Update to Downstream PHY High Level Block Diagram – R01

Avi Kliger, Mark Laubach
Broadcom

EPoC Downstream **CLT** Transmitter Block Diagram

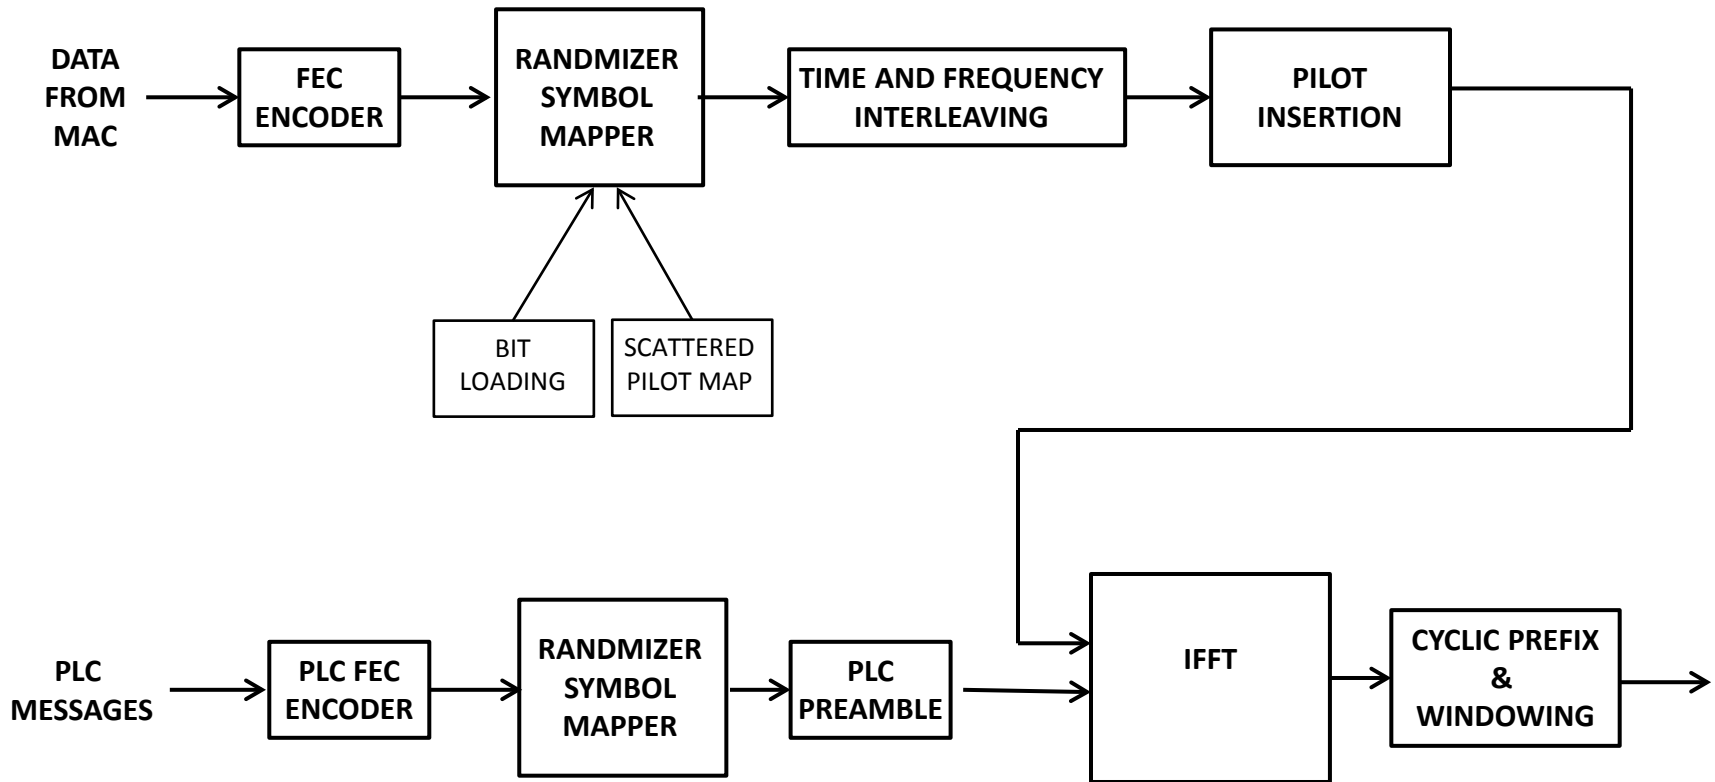
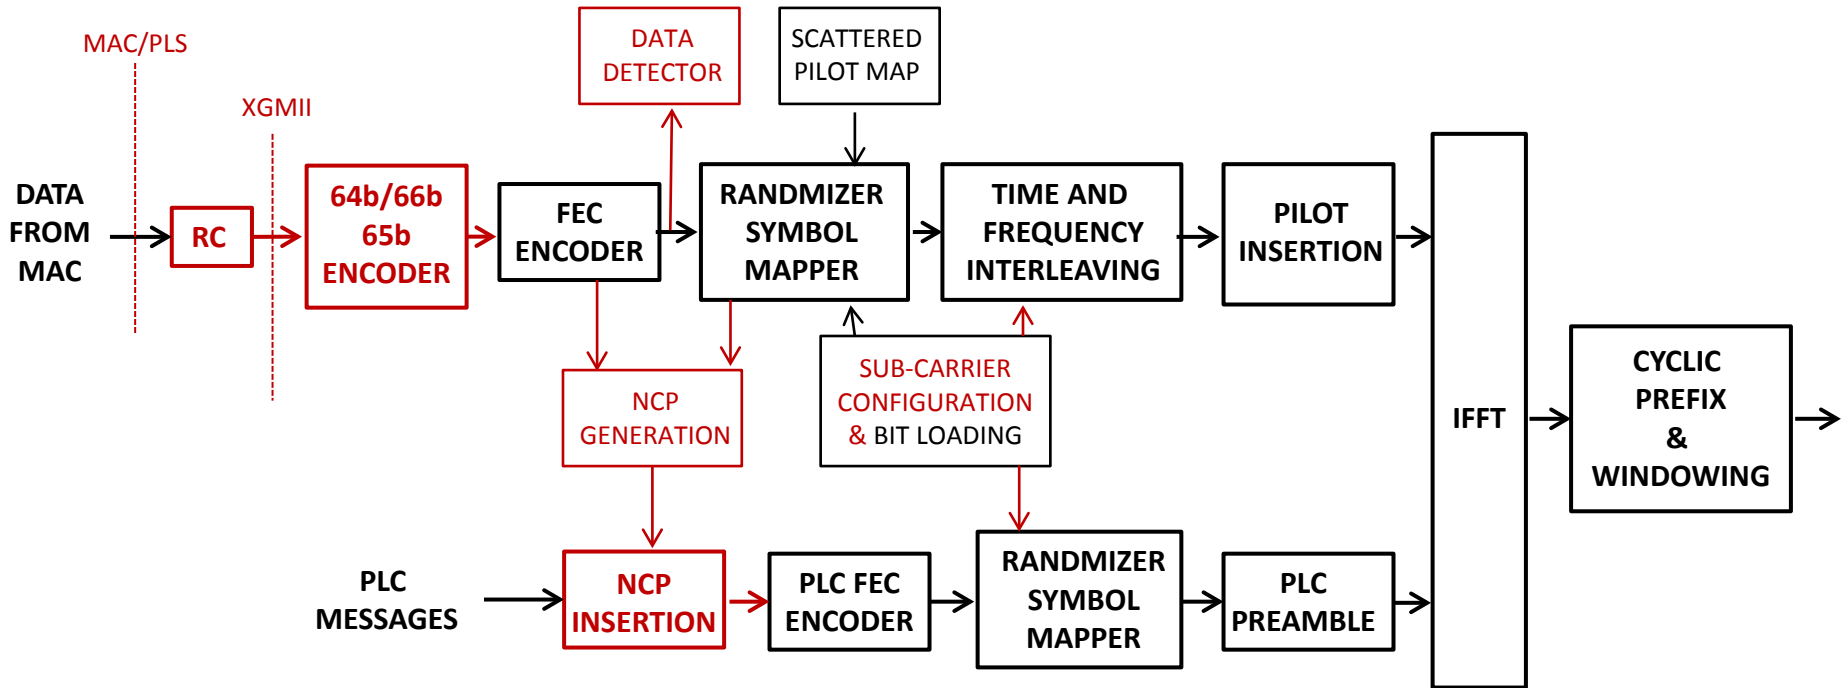
NOTE: Sub-Carrier Configuration includes sub-carrier use and QAM mapping

NOTE: Not converted yet to IEEE 802 Vertical Form
